March 7, 2003

SUBJECT: SUMMARY OF FEBRUARY 13, 2003, MEETING WITH INDUSTRY AND
THE NUCLEAR ENERGY INSTITUTE (NEI) TO DISCUSS RADIATION
SAFETY CORNERSTONES

PUBLIC RADIATION SAFETY SIGNIFICANCE DETERMINATION PROCESS

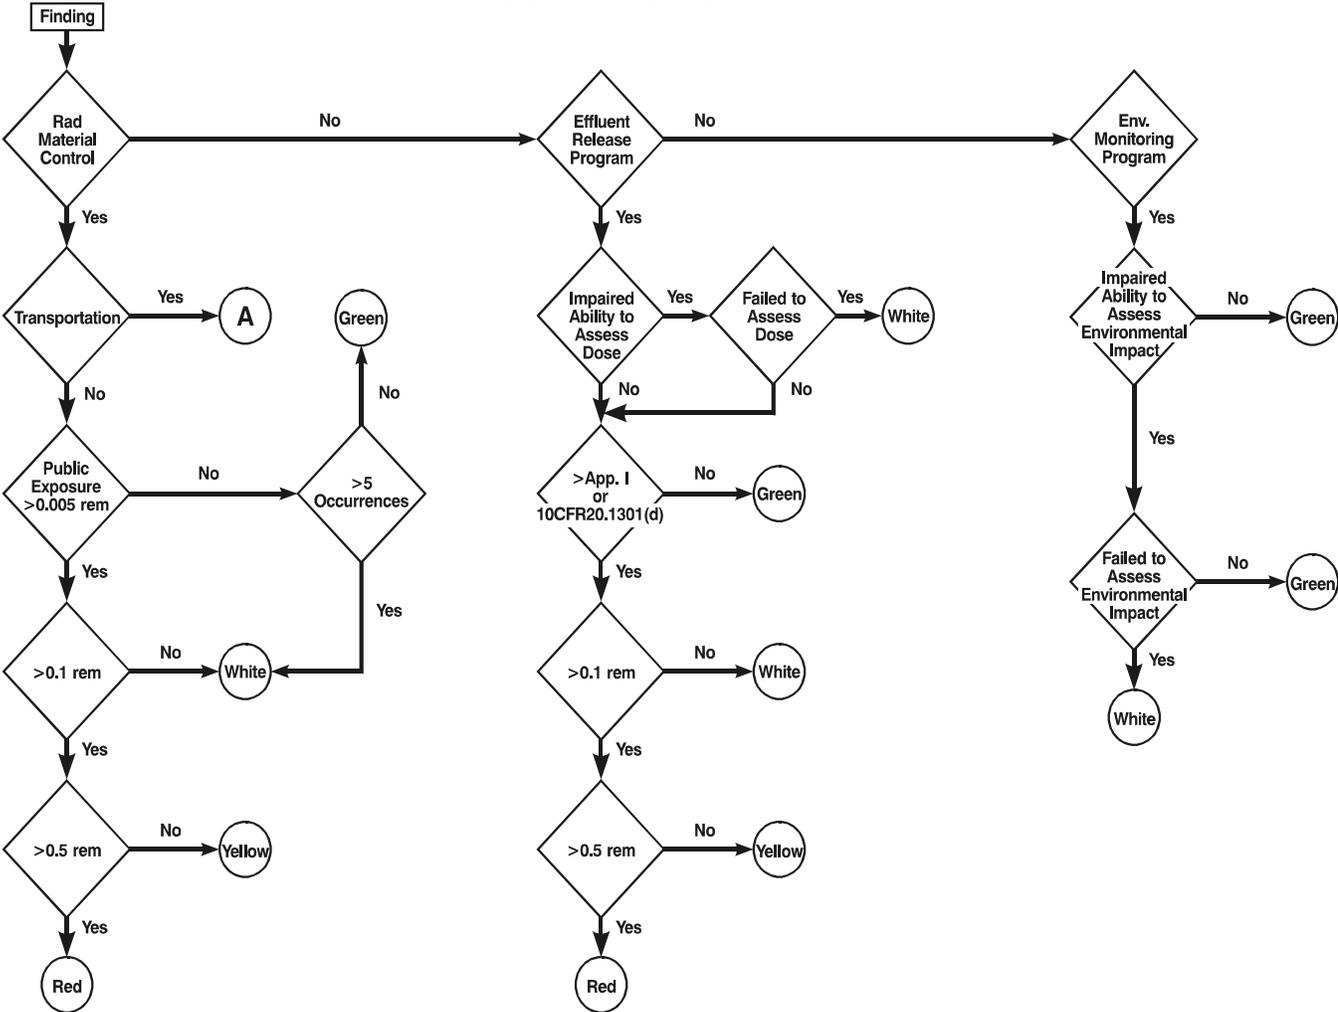
~~Historically, these events have had calculated doses well below 0.001 rem TEDE, thus, in most cases a GREEN significance determination is likely. However, if there were more than 5 occurrences in the assessment period where licensed radioactive material was released, there is a potential for the cumulative dose from the occurrences to be 0.005 rem TEDE or greater. This will result in a WHITE classification.~~

For a finding which involves licensed radioactive material within the licensee's Protected Area or Restricted Area (as defined in 10 CFR Part 73 and Part 20, respectively), the finding will not be counted as an occurrence by the "greater than 5 Occurrences" decision block. This is because licensed radioactive material within a licensee's Protected Area or Restricted Area involves negligible risk to members of the public in an Unrestricted Area.

Individuals who have not been classified as receiving "occupational dose" are sometimes permitted access to a licensee's Protected or Restricted Area for job-related or public information purposes. Such individuals are either physically escorted or are granted limited unescorted access following the successful completion of appropriate orientation training and security screening. For the purposes of this SDP, such individuals are classified as "Members of the Public." Exposure received by such individuals associated with a radioactive material control finding involving licensed radioactive material in a Protected or Restricted Area will be evaluated using the dose-based criteria in the SDP (e.g., greater than 0.005, 0.1, or 0.5 rem TEDE, respectively), although, as stated above, such findings will not be counted as an occurrence.

It is acceptable to document in an inspection report, multiple related instances of licensed radioactive material being identified outside of a Protected Area, Restricted Area, or an area defined by the licensee in which licensed radioactive material is controlled, as a single finding in the following circumstances; 1) instances that do not represent a performance deficiency and 2) licensee identified instances that represent a performance deficiency that stem from a common root cause or are the result of investigations and surveys conducted in conjunction with a corrective action plan.
